Re: Turkey Point Plant Unit No. 3
Docket No. 50-250
Proposed Amendment to Facility
Operating License DPR-31

This submittal proposes a change to Section 2.B which will allow storage of 235 fuel assemblies in the Unit 3 spent fuel pit. This increase from 217 fuel assemblies will be a temporary change which will be in effect less than one year. The revised section should read as follows:

TEMPORARY SPENT FUEL STORAGE RACK MODULE

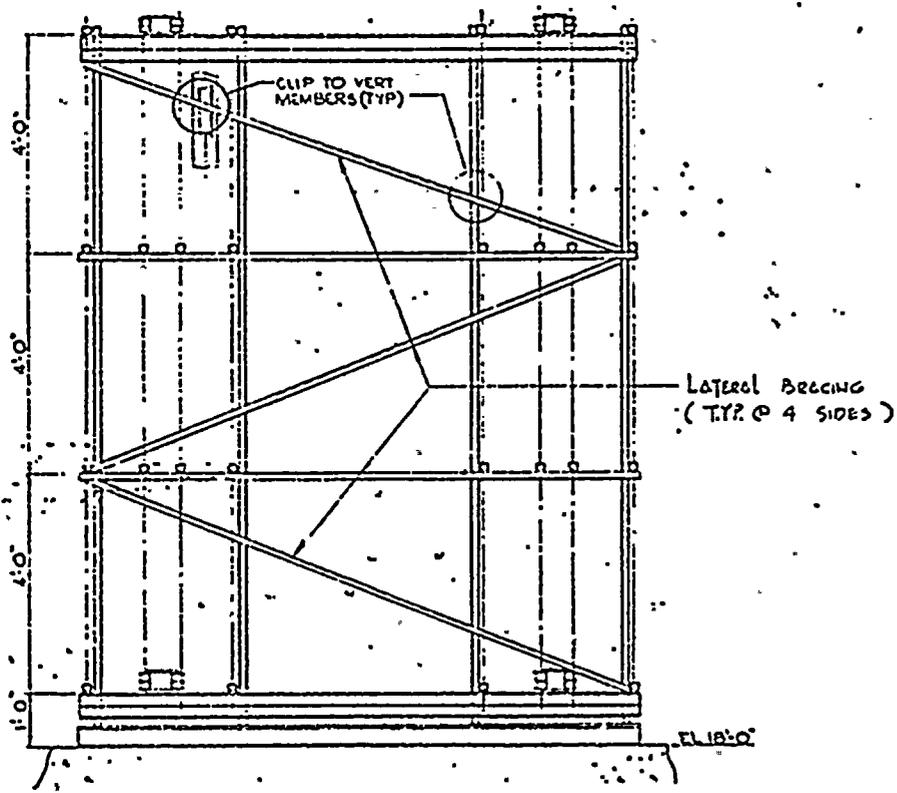
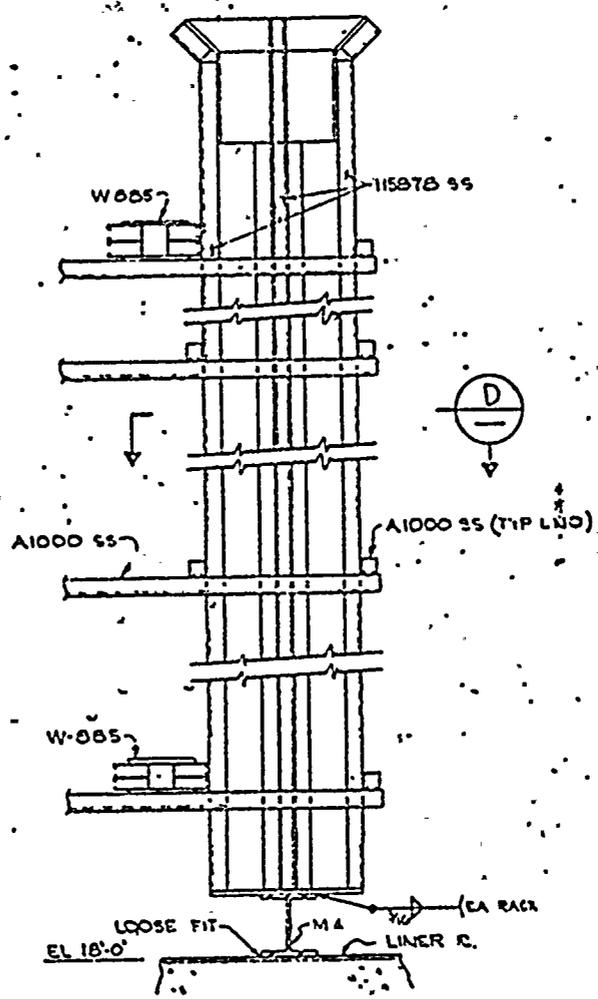
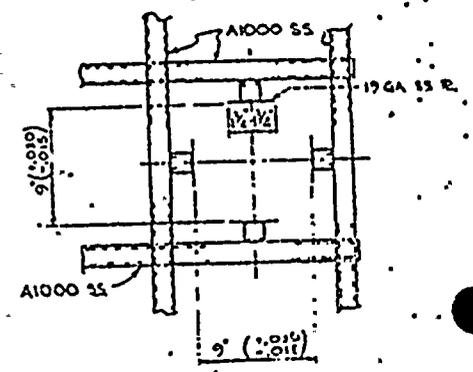
The temporary storage racks will be fabricated into a Seismic Class 1 structural module containing 18 storage locations. The existing rack dimensions, center-to-center spacing (21"), and structural characteristics are maintained in the temporary storage module. The module will be placed in the Unit 3 spent fuel cask area of the pool and will be fitted to the existing structural framework. The module will be lifted by four lifting lugs. After the module is in place, the lifting slings are removed and the lifting lugs swing down and act as a shim (See Figure 1, Sheet 3) to close the measured gap between the existing racks and the temporary module. The shimming of the module to the existing racks and spent fuel pit wall creates a seismically integrated assembly. Details of the temporary fuel storage module are shown in Figure 1.

The modification reduces the existing cask loading area as shown in Figure 1. However, during the time the temporary racks are in use, fuel transfer operations will be accomplished using a single element cask. Cask handling is described further in Reference 2. In the unlikely event of an unscheduled cask descent, the evaluation of offsite doses remain the same as that described in Reference 2.
